RS-10-020

January 25, 2010

U.S. Nuclear Regulatory Commission
ATTN: Document Control Desk
Washington, DC 20555-0001Byron Station, Units 1 and 2
Facility Operating License Nos. NPF-37 and NPF-66
NRC Docket Nos. STN 50-454 and STN 50-455Subject: Additional Information Supporting Request for License Amendment Regarding
Ultimate Heat Sink

ATTACHMENT 1
Response to Request for Additional Information

INSERT 3.7.9-1

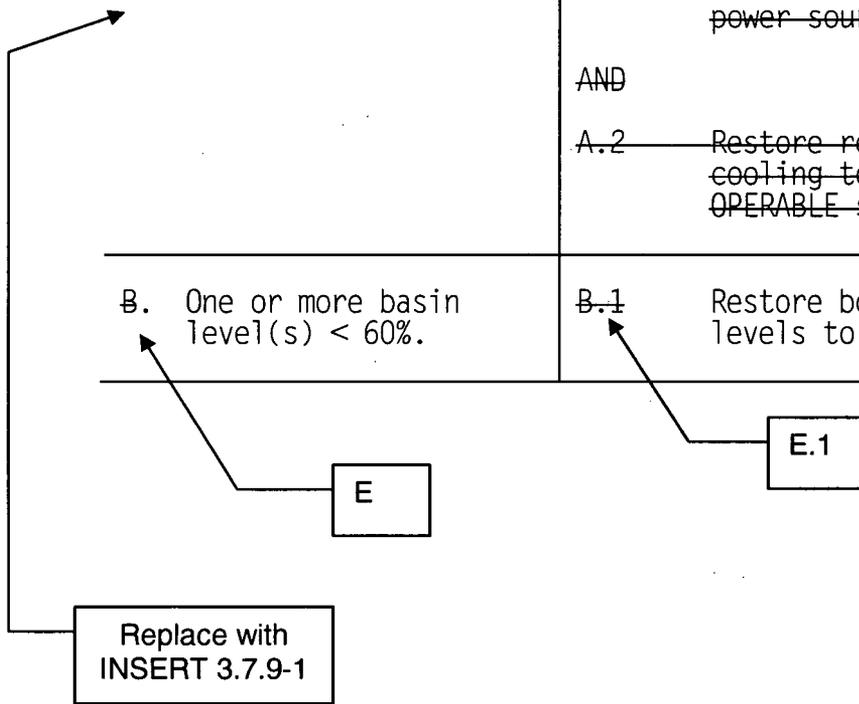
The fan requirements of the UHS are dependent on the SX pumps' discharge temperature. New TS Table 3.7.9-1 states these fan requirements and defines the associated Limiting Condition for Operation (LCO). Note (a) of this table could be construed to reduce the fan requirement when in Condition B. Since this note is associated with the column of the table that specifies LCO requirements, an interpretation of Note (a) could imply that the fan requirements for the LCO are satisfied if in Condition B and there is one less fan running in high speed. Then one might conclude the plant is no longer in Condition B. This could present confusion as to the actual condition of the UHS.

Furthermore, Condition A explicitly states that if one or more required cooling tower fans are not running in high speed, then actions must be taken immediately to correct the condition and, if not corrected immediately, then Condition J should be entered and the plant must be shutdown. This would mean that when the plant was running high speed fans to meet the LCO requirements of Table 3.7.9-1 with the other fans out of service, failure of one or more of the running fans would cause entry into Condition J and Mode 3 in 6 hours. The same situation would exist if SX temperature increased such that an additional fan in high speed was required in accordance with Table 3.7.9-1 and an additional fan was not available.

In response to the concern for possible misinterpretation with Note (a) of Table 3.7.9-1 and its relationship to Conditions A and B, Note (a) has been eliminated from Table 3.7.9-1, and Condition A has been reworded to read "One or more OPERABLE cooling tower fan(s) not running in high speed as required by Table 3.7.9-1." The proposed note for Condition A has also been eliminated. As defined in the TS Bases, an operable cooling tower fan must be capable of running in high speed. If Table 3.7.9-1 requires operable cooling tower fans to be running in high speed and one or more are not, then required Action A.1 would direct actions to be initiated immediately to place those required operable fan(s) that are currently operable in high speed mode. If Table 3.7.9-1 requires operable cooling tower fans to be running in high speed and one required fan is not capable of running in high speed, then the fan is considered inoperable. In this case, Condition B would apply. Condition A would not apply to this situation, since the fan is not operable. If Table 3.7.9-1 requires operable cooling tower fans to be running in high speed and more than one required fan is not capable of running in high speed, then these fans are considered inoperable. In this case, Condition J would apply.

Table 3.7.9-1 has been revised to encompass all SX pump discharge temperature ranges. Subsequently, the word "ADDITIONAL" has been removed from the heading of the second column of Table 3.7.9-1, and SR 3.7.9.2 has been revised to read "Verify cooling tower fan requirements in Table 3.7.9-1 are met."

The LCO statement has been revised to state "The UHS shall be OPERABLE and the SX cooling tower fans shall be OPERABLE and operating as specified in Table 3.7.9-1." This revision ensures consistency with other LCOs that contain tables that further define the LCO requirements. In addition, a typographical error was corrected in Required Action B.2; the word "fans" has been changed to "fan."

Condition C has been modified to read "Two inoperable cooling tower fans not required to be OPERABLE by Table 3.7.9-1 that are powered by the same electrical division." Attachment 2 provides the revised markups of the affected TS pages.

<p>A. One or more OPERABLE cooling tower fan(s) not running in high speed as required by Table 3.7.9-1.</p>	<p>A.1 Initiate actions to operate OPERABLE cooling tower fan(s) in high speed.</p>	<p>Immediately</p>
<p>B. One required cooling tower fan inoperable.</p>	<p>B.1 Verify remaining required OPERABLE cooling tower fans are capable of being powered by an OPERABLE emergency power source.</p>	<p>1 hour</p>
	<p><u>AND</u></p> <p>B.2 Restore required cooling tower fan to OPERABLE status.</p>	<p>72 hours</p>
<p>C. Two inoperable cooling tower fans not required to be OPERABLE by Table 3.7.9-1 that are powered by the same electrical division.</p> <p><u>AND</u></p> <p>Outside air wet bulb temperature > 76°F.</p>	<p>C.1 Restore cooling tower fan configuration such that two inoperable cooling tower fans are not powered by the same electrical division.</p>	<p>72 hours</p>
<p>D. Essential Service Water (SX) pump discharge temperature > 96°F.</p>	<p>D.1 Be in MODE 3.</p>	<p>6 hours</p>
